## APPENDIX C

**Technical Specification Change 001****Justification for change:**

**Technical Specification Change 002**
**Justification for change**

Figure B 3.2.3-1 (page 1 of 1)  
AXIAL FLUX DIFFERENCE Acceptable Operation Limits and Target Band Limits as a Function  
of RATED THERMAL POWER

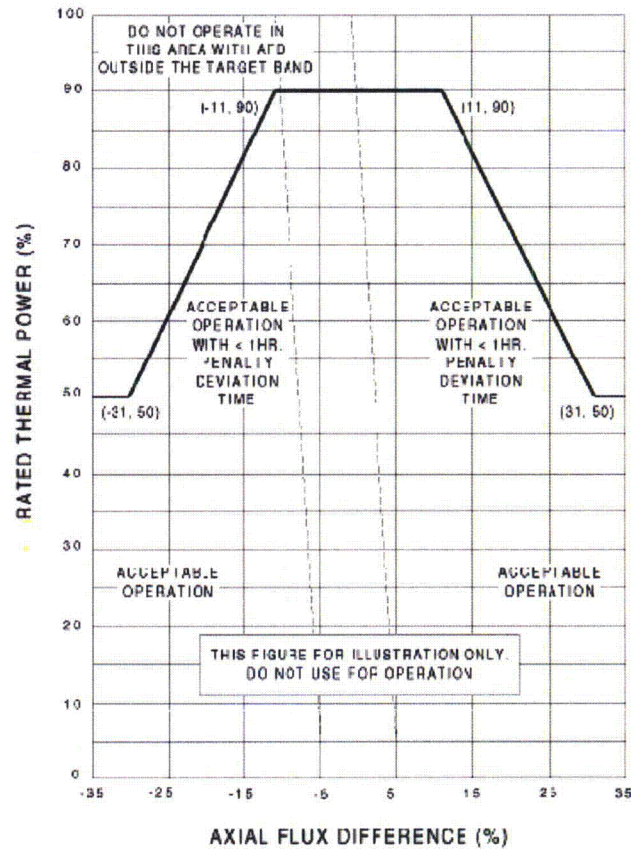
Deleted: The AFD limits are provided in the COLR. Figure B 3.2.3-1 shows typical RAOC AFD limits. The AFD limits for RAOC do not depend on the target flux difference. However, the target flux difference may be used to minimize changes in the axial power distribution.

Figure B 3.2.3-1 shows a typical target band and typical AFD acceptable operation limits.
